**Planning Permission for an Extension and Renovation of  
The Cuckoo's Nest Public House, Greenhills Road, Tallaght, Dublin 24.**

**CLARIFICATION OF ADDITIONAL INFORMATION**

**Reg Ref: SD22A/0285**

Fig. 1 – Location of proposed SuDS features on site.

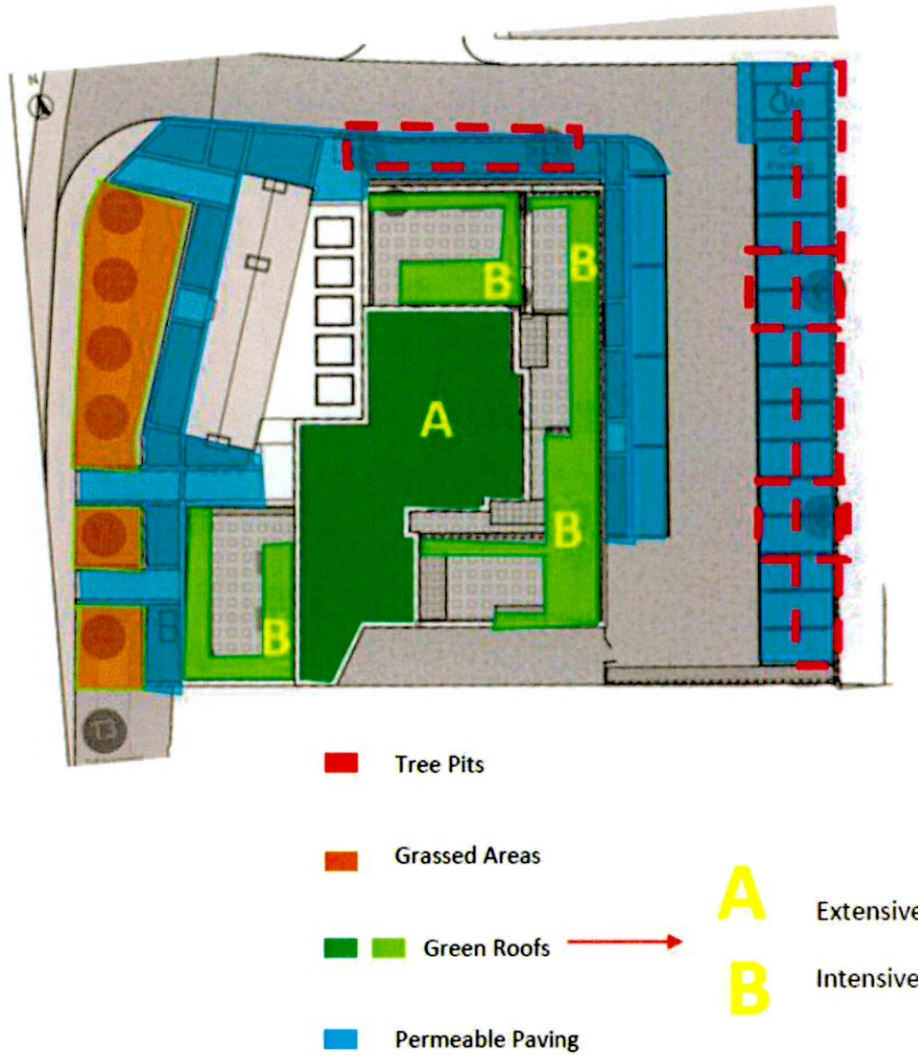
*i. Demonstrate the treatment train, biodiversity value and amenity value of the SUDS proposals for the catchment in the residential areas.*

Please refer to the submitted CORA Consulting Engineers drawing no. C102 “Proposed Surface Water Management Schematic”. In addition, page 8 of the submitted RMDA report provides a schematic of the distribution and location of SuDS features throughout the site, as illustrated in Figure 1 overleaf:
